Service Bulletin

SAFETY RECALL

2003-2004 GL1800/A

Frame Weld

WELDING OVERVIEW

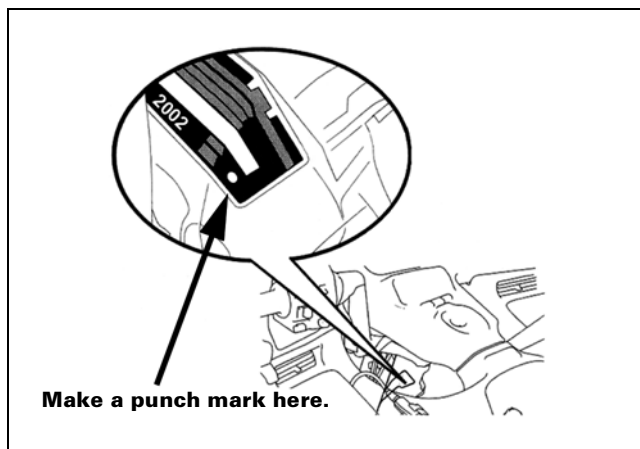
A qualified TIG welder will weld the frame following the procedures in the *2002-2003 GL1800/A Frame Weld Safety Recall Welding Manual*.
